Work Order ID 103444

Parent Item Name: Replacement Exterior Window for -111

DRAWING NO. D3290	TITLE REPLACEMENT WINDOW ASSEMBLY	REV. C	DART AEROSPACE LTD ENGINEERING ORDER		D.E.O. NO. D3290-C-1	SHEET NO. SHEET 1 OF 1	SCALE NTS
DRAWN <i>qp</i>	CHECKED <i>ls</i>	MFG. APPR. <i>FE</i>	APPROVED <i>MP</i>	DE APPR. <i>#</i>			
DATE 09.09.18	DATE 09.09.18	DATE 09.09.18	DATE 09/09/21	DATE 09/09/21

D3290-1 FRAME

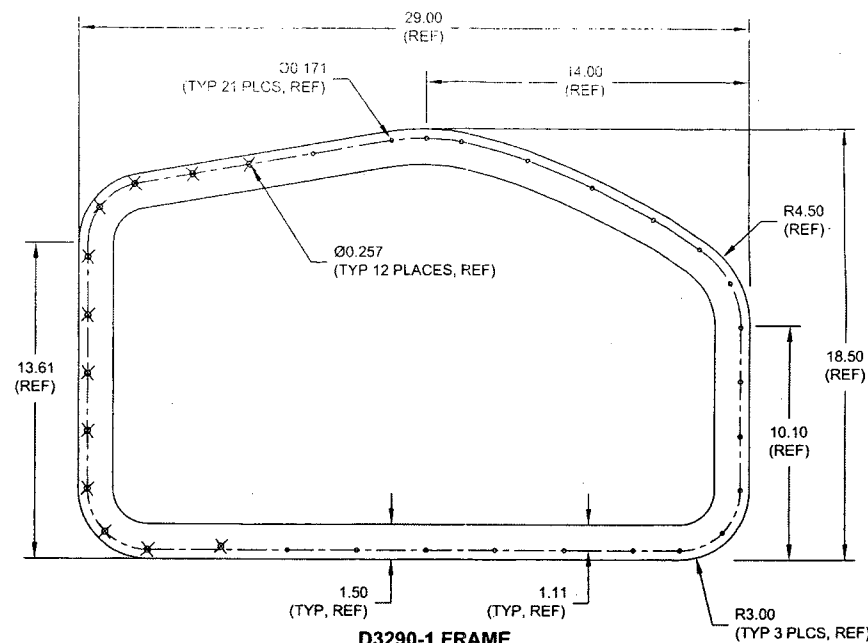
CHANGE MATERIAL THICKNESS OF D3290-1 FRAME TO 0.063 FROM 0.040. REF PAR 09-033.

MATERIAL CALL-OUT OF D3290-1 FRAME ON SHEET 1 IS AMENDED AS FOLLOWS:

- 1) MATERIAL: 6061-T6 (OR 6061-T62) ALUMINUM SHEET ~~0.040 THICK~~ 0.063 THICK (REPLACE)
 PER AMS-QQ-A-250/11 OR AMS 4025 OR AMS 4027
~~(REF. DART SPEC. M6061T6S.040)~~ REF. DART SPEC. M6061T6S.063 (REPLACE)
 OR
 5052-H32 ALUMINUM SHEET ~~0.040 THICK~~ 0.063 THICK (REPLACE)
 PER AMS-QQ-A-250/8 OR AMS 4016
~~(REF. DART SPEC. M5052H32S.040)~~ REF. DART SPEC. M5052H32S.063 (REPLACE)
